## DEVIATION REQUEST AND DECISION FORM

### Deviation No. 1 (Revised 2-29-20)

### PCD File No. PPR-0199

Project Name :	Monument Academy Charter School
Schedule No.(s) :	6100000245
Legal Description :	THAT PART OF NW4 LY ELY OF E R/W LN OF HWY 83 EX RD, E S 200 FT OF SE4NW4, EX 0.49 A TO AMERICAN TEL + TEL SEC 15-11-66

TYPICAL SECTIONS &  
DESIGN DATA -  
PINEHURST CIRCLE

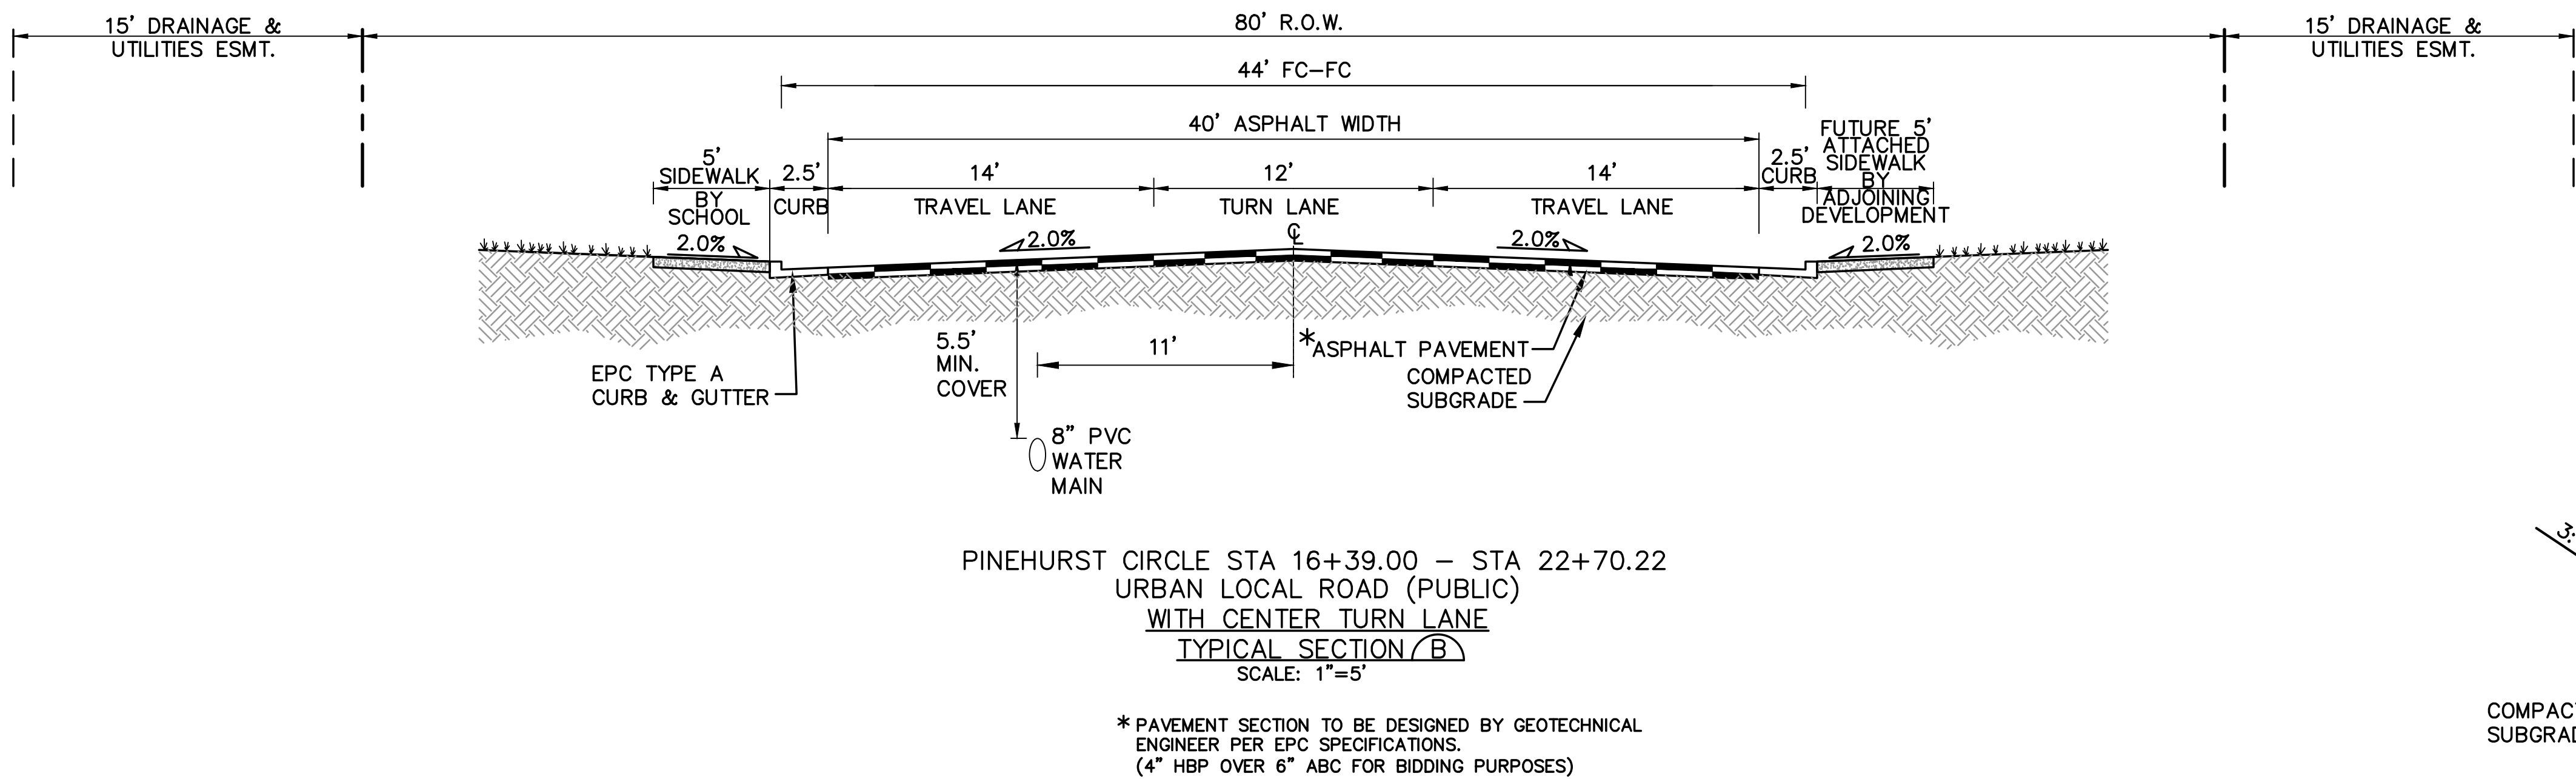
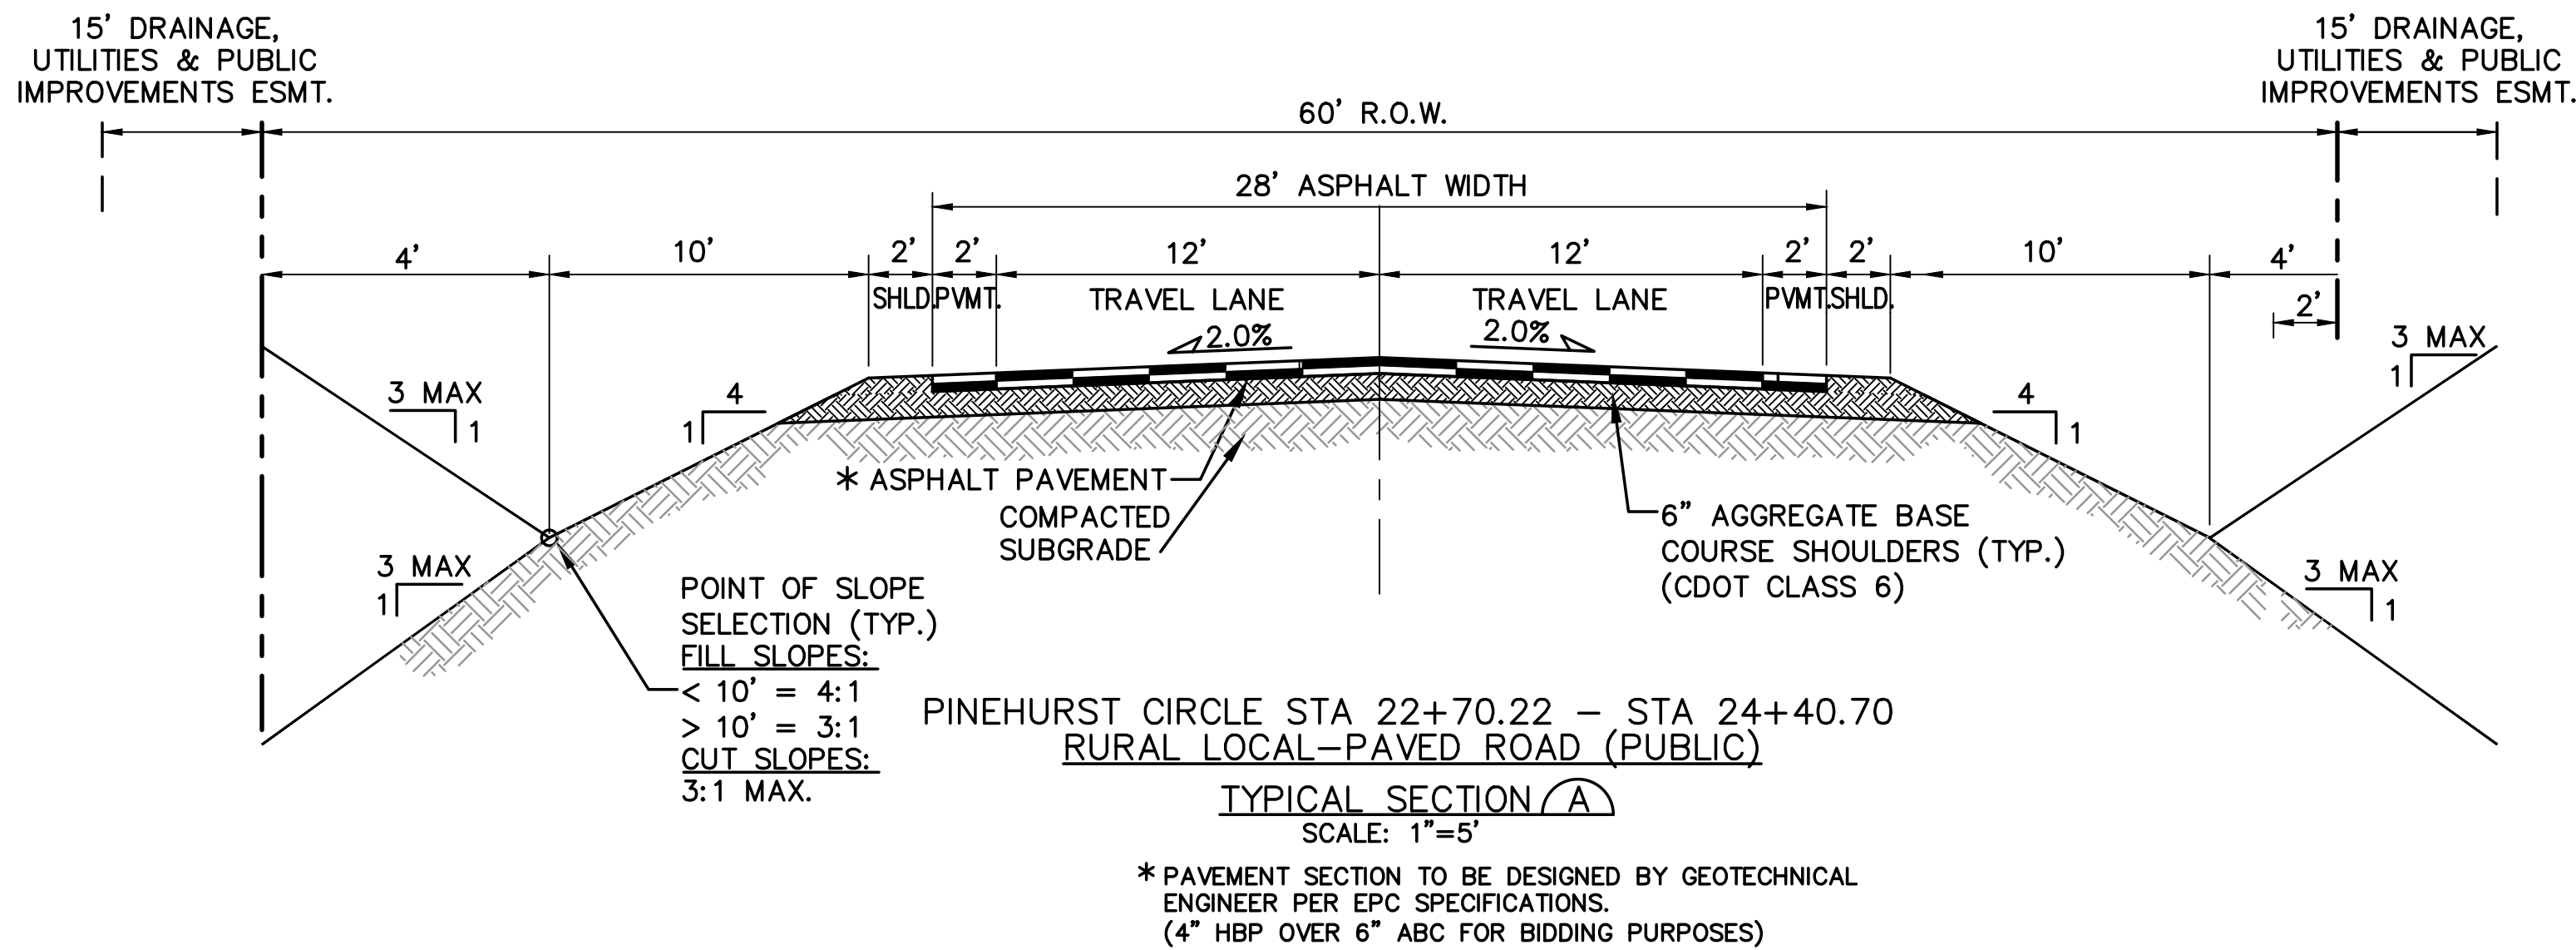
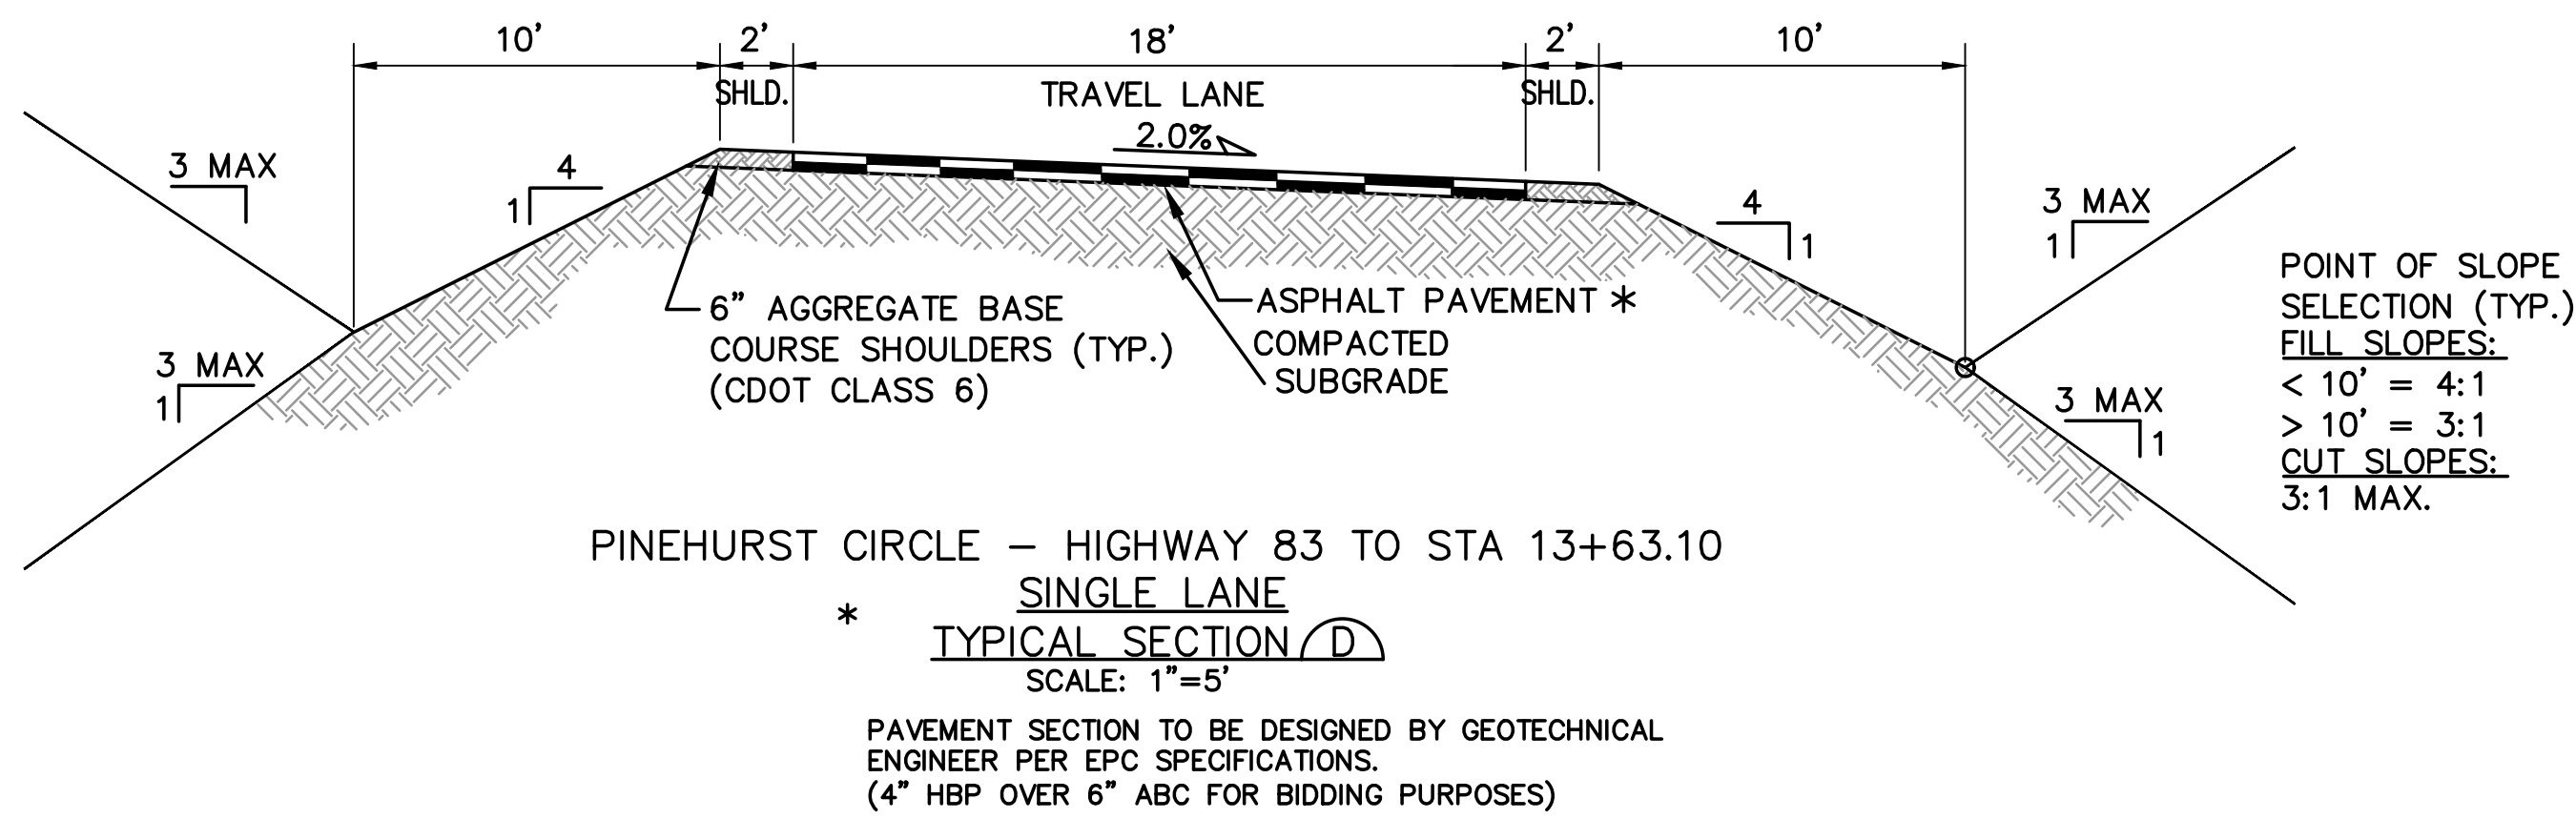
- Table 2-7 Urban Non-Residential Collector Design Speed and Centerline Curve Radius
- Section 2.2.4.B.4 Urban Non-Residential Collector Road Cross Section (Figure 2-14)
- The deviation is for the new public street segment of Pinehurst Circle extending easterly from SH83 to the intersection with Jane Lundeen Drive. The ECM-prescribed design speed is 40 MPH, and the ECM-prescribed minimum centerline radius is 565 feet, for an urban non-residential collector. This deviation request is to allow for a design speed of 25 MPH and a minimum centerline radius of 200 feet as depicted on the attached Plan & Profile Drawing (Sh. PP1). In conjunction with design of the approach to the proposed Mini-Roundabout, special cross-sections for this one-lane road segment have been developed as shown on the attached Typical Section Drawing (Sh. TY1).

The proposed design speed of 25 MPH and the proposed minimum centerline radius of 200 feet are both consistent with County standards for Urban Local roadways.

*APPROVED DEVIATION:	URBAN LOCAL
ROAD CLASSIFICATION:	URBAN LOCAL
DESIGN SPEED:	25 MPH ECM TABLE 2-5
MIN. K-VALUE (CREST):	12 ECM TABLE 2-13
MIN. K-VALUE (SAG):	26 ECM TABLE 2-15

DEVELOPED DRAINAGE  
PLAN

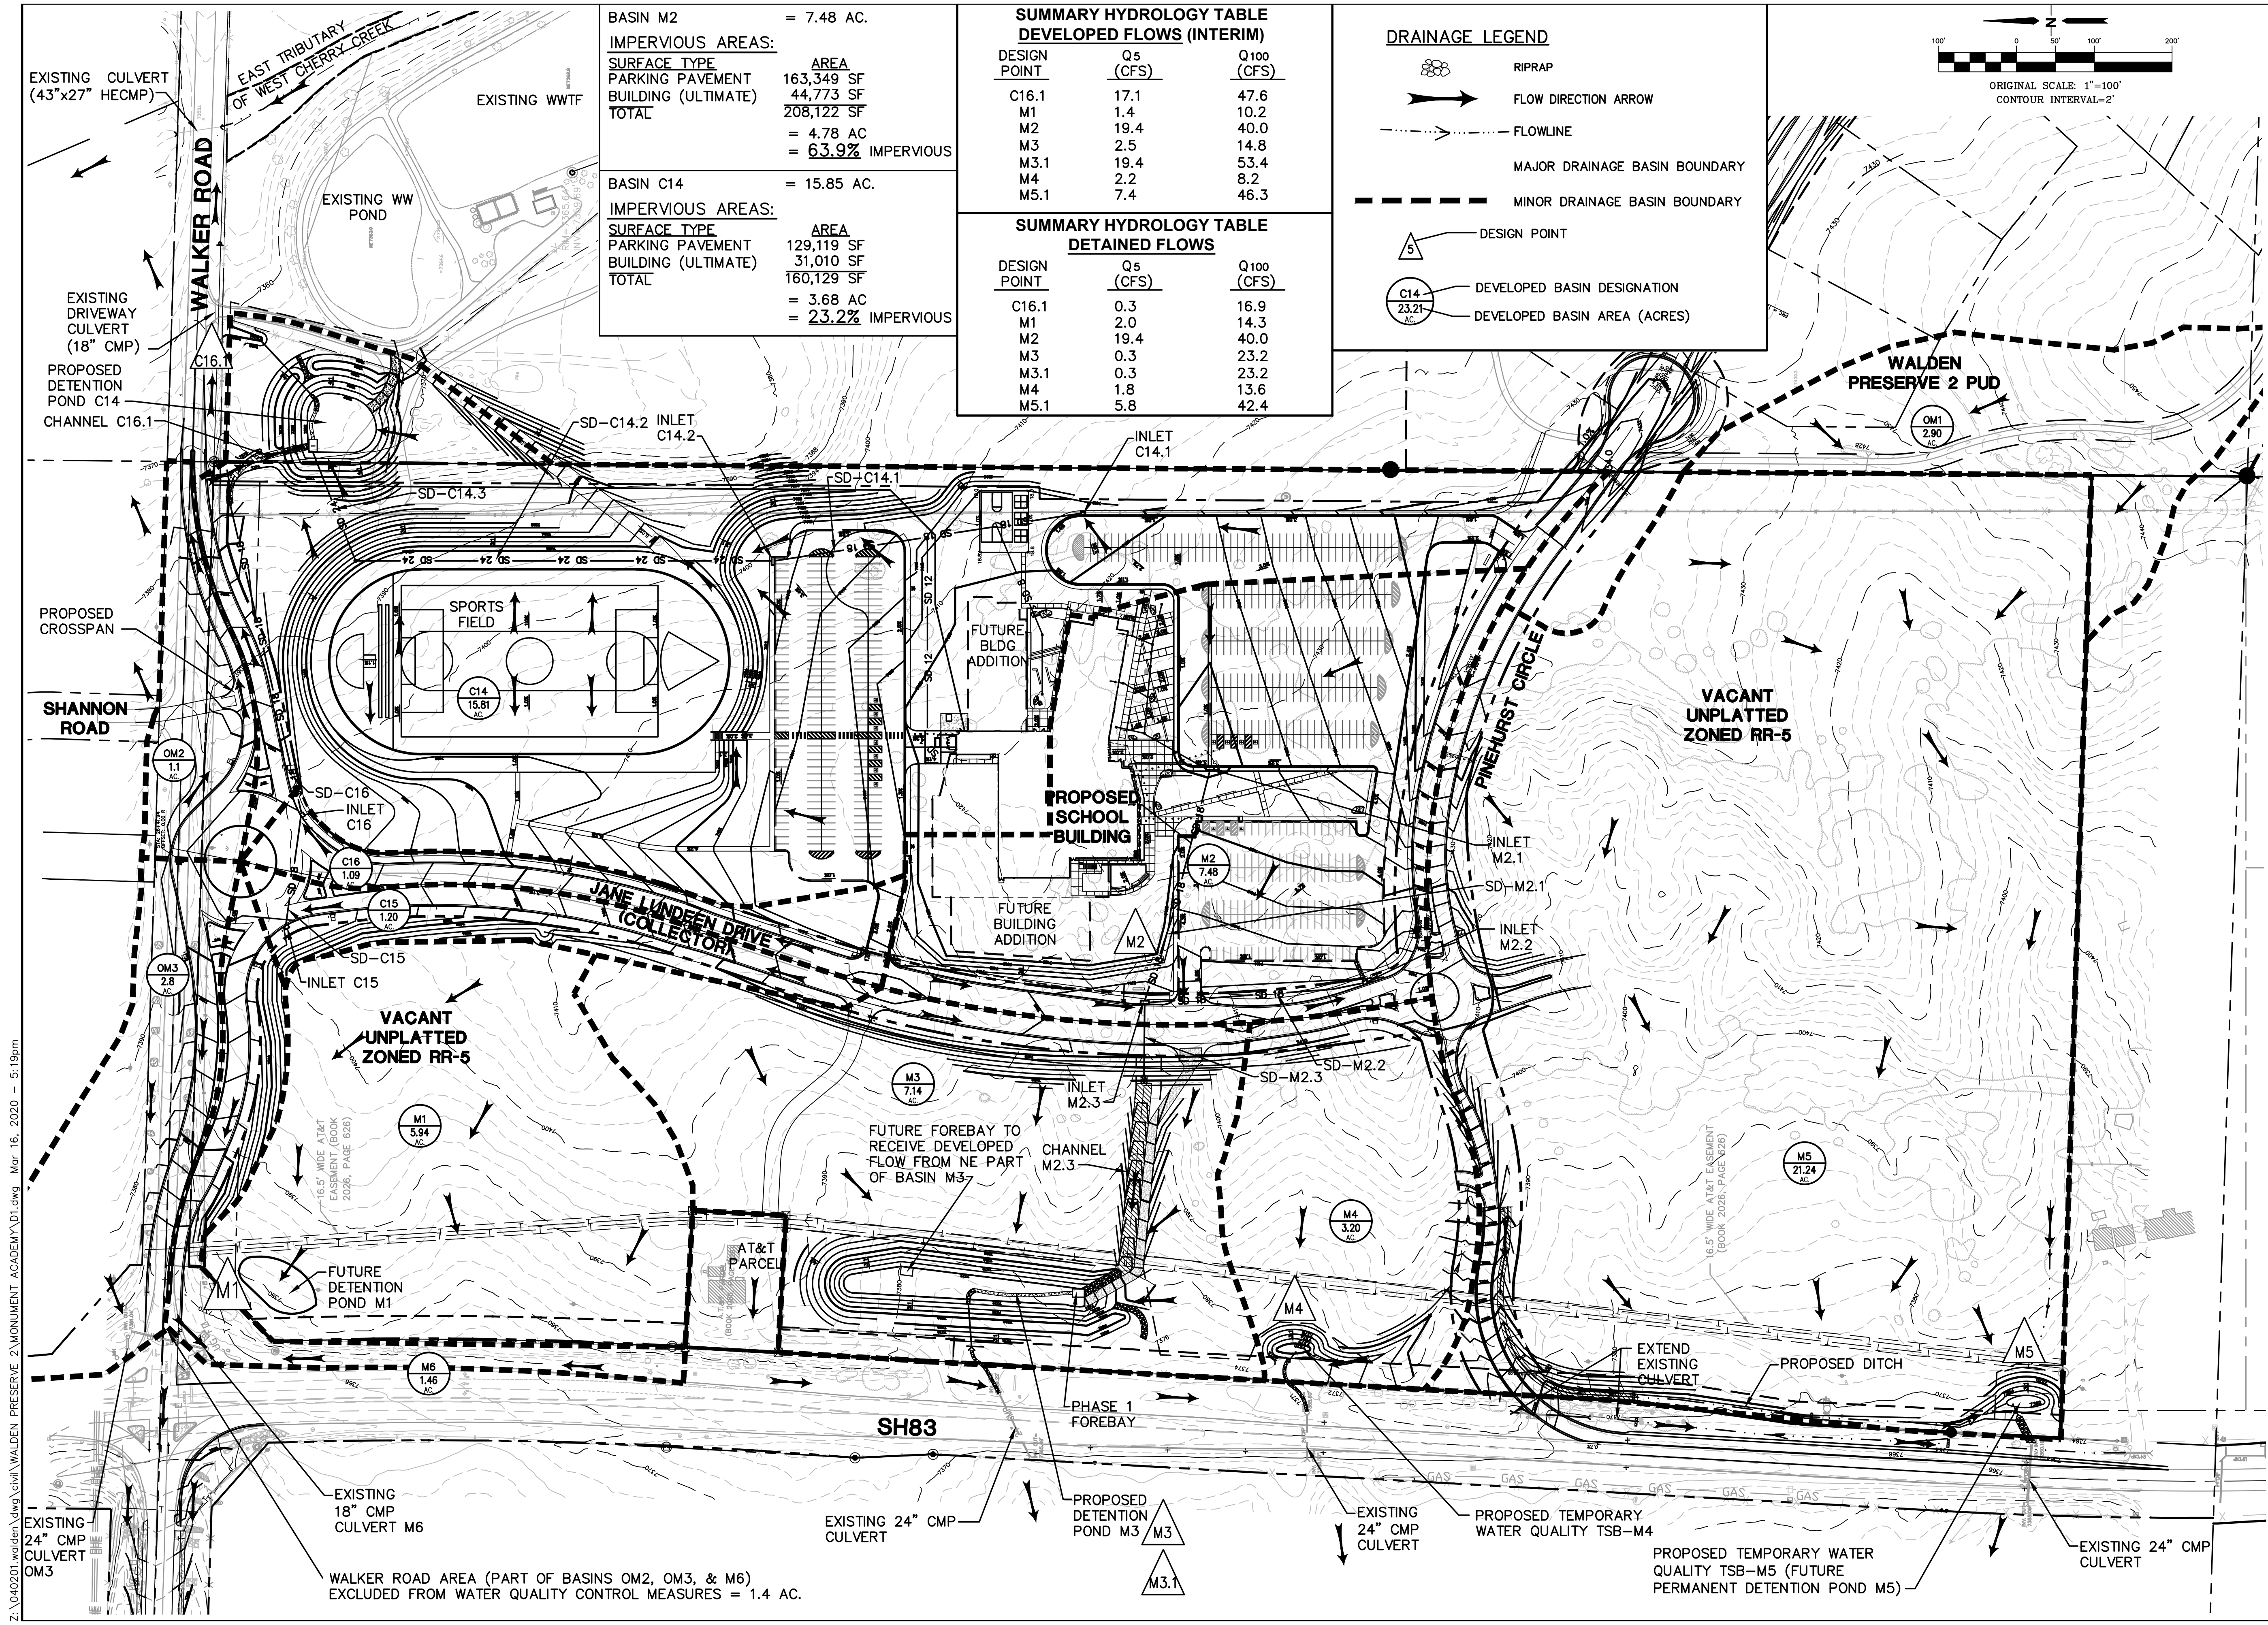
Section 3.2.5.A - Space Planning; Section 3.2.5.E. Stormwater Quantity and Quality

Additionally, the use of temporary sediment basins as non-standard BMPs in two locations (Temporary Water Quality Ponds M4 and M5) is based on ultimate plans for permanent stormwater detention and water quality facilities serving these locations.
